KILDARE COUNTY COUNCIL

Type of Development	Cycle Scheme
Site Location	Dublin Road roundabout (Naas Ball) to the Slí na Naomh junction east of Kill village, via Johnstown and Kill village.
Development proposed by	Sustainable Transport
Display period	Advertised in the Nationalist and in the Leinster Leader on the 6 th September 2022 Public display period from 7 th September 2022- 5 th October 2022 Submissions to be made by 19 th October 2022
Submissions/observations	47 No. submissions received. A report on the submissions is included in Appendix B. A list of people who made submissions/observations is provided in Appendix C
Part 8 Reference Number	P82022.17

APPENDIX B
SUBMISSION REPORT (Sustainable Transport)

Naas to Kill (via Johnstown Village) Cycle Scheme, Co Kildare

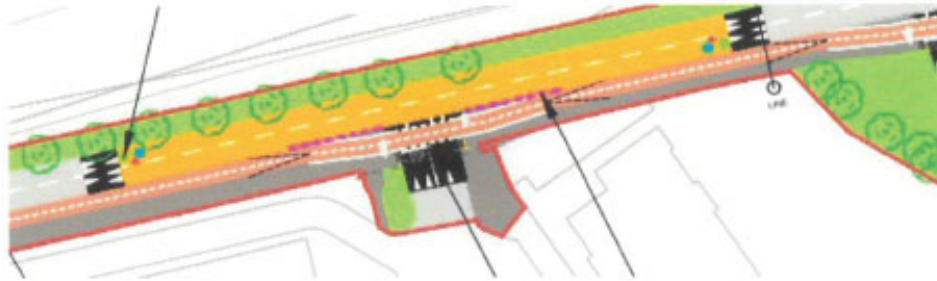
October 2022 proposal indicates that the access to Scoil Bhríde is no longer a mini roundabout.

Will traffic be allowed to turn right on exiting the school? We note that the new junction will see the current right filter lane removed. The committee feel that this will lead to significant traffic delays. Traffic to Dublin will be unable to pass school traffic on the left as is currently the case. Currently traffic exiting Scoil Bhríde must turn left and must continue their journey northbound via the Earls Court mini roundabout. However, this proposal will see the Earls Court mini roundabout removed. How will traffic exiting the school continue journey northbound. We fear that Earls Court will be used as a "rat run" for school traffic heading northbound via Hillfort.

1. Removal of right turning lane into Scoil Bhríde.

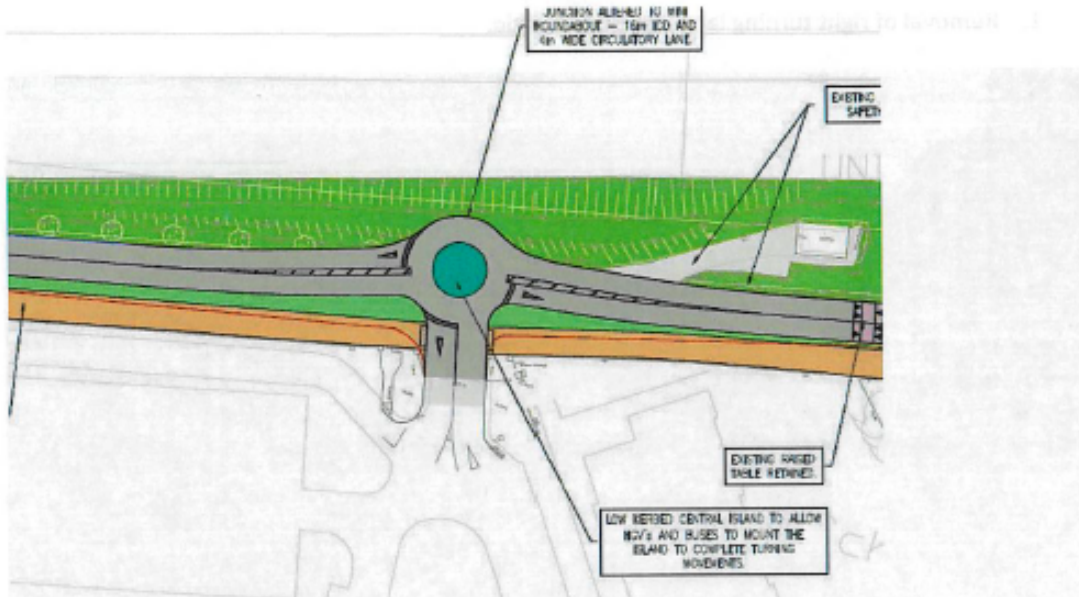
Any vehicles waiting to turn right into Scoil Bhríde will block traffic, causing major delays through Kill.

2022 Proposal P82022.17 Drawing 40000089-WSP-DG-HW-0106-07

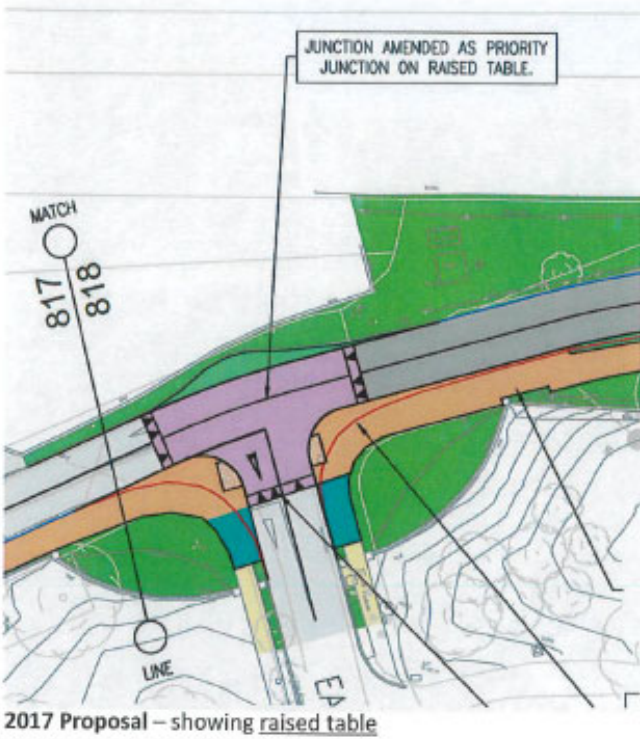
Noting removal of roundabout at Scoil Bhríde. This will promote the continued dangerous driving behaviours by drivers exiting the school.

6. Vehicles parking in cycle Lanes

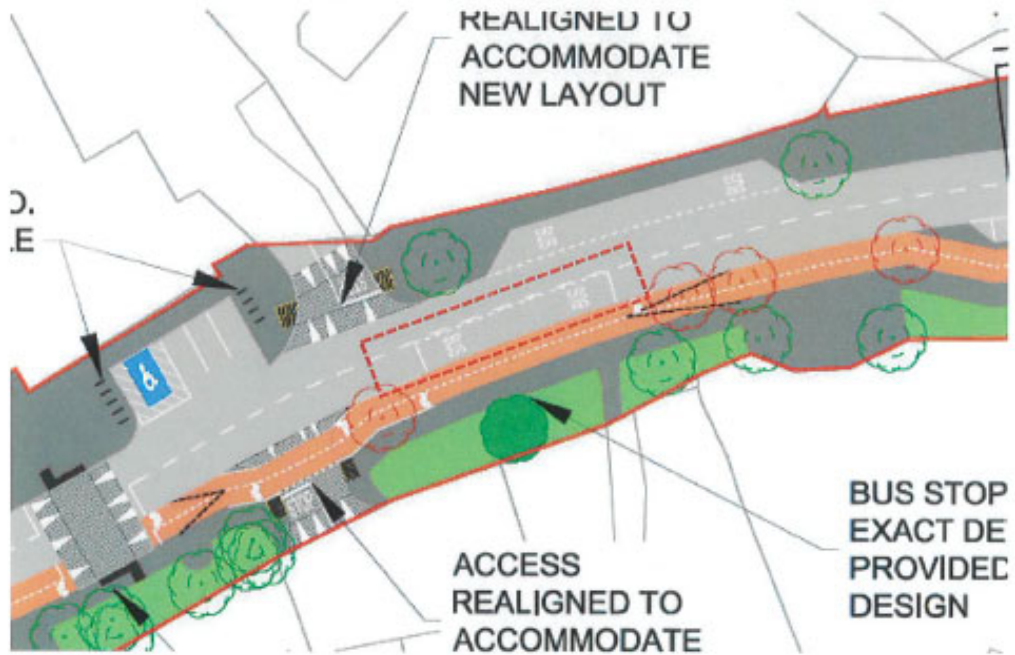
Vehicles Park on current shared footpath/cycle path directly outside Scoil Bhríde (photo 18.10.22) causing a serious risk to School Children, Pedestrians and Vehicles. This will continue unless a barrier between the carriageway and cycle path is installed.
